To: T10 Technical Committee
 From: Bob Sheffield (Robert.L.Sheffield@intel.com)
 Vicky Duerk (vicky.p.duerk@intel.com)
 Date: 27 January 2007
 Subject: SAS-2: Initiator handling of retransmit read DATA frames

Revision 0 (27 October 2006) First revision (This is the first half of the split up proposal : 06-371r0)
 Revision 1 (9 January 2007) Incorporate changes from November '06 SAS WG
 Revision 2 (27 January 2007) Incorporate changes from January '07 SAS WG (replace table with simple text)

Figure 1 — Representation of transport layer (i.e., ST_TTS6) read data operation

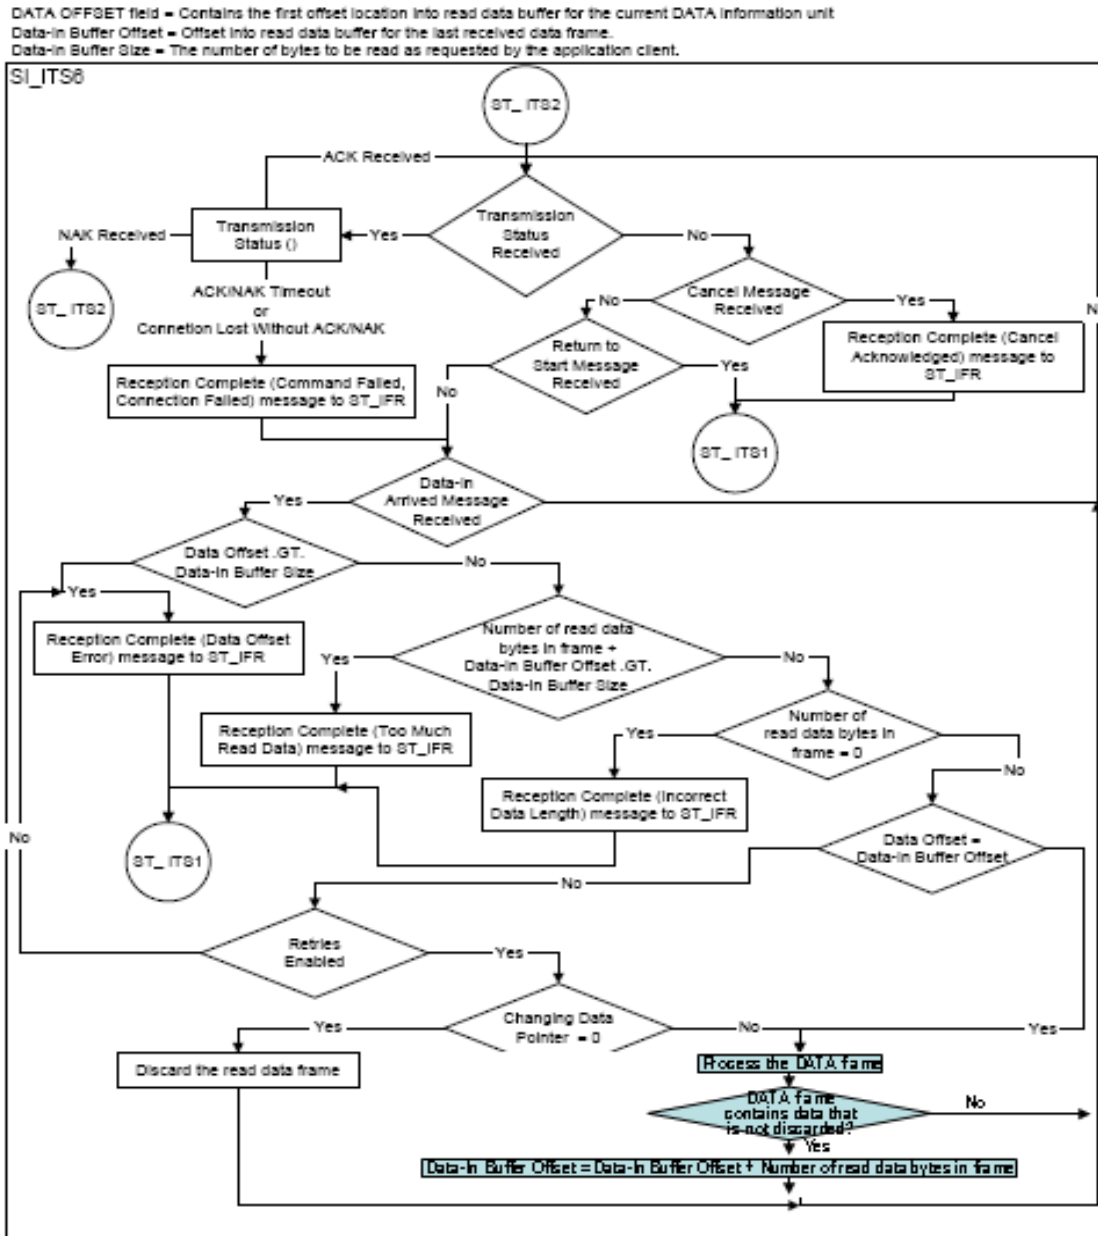
The flow chart in 06-489r0 should be modified as shown in the following figure:
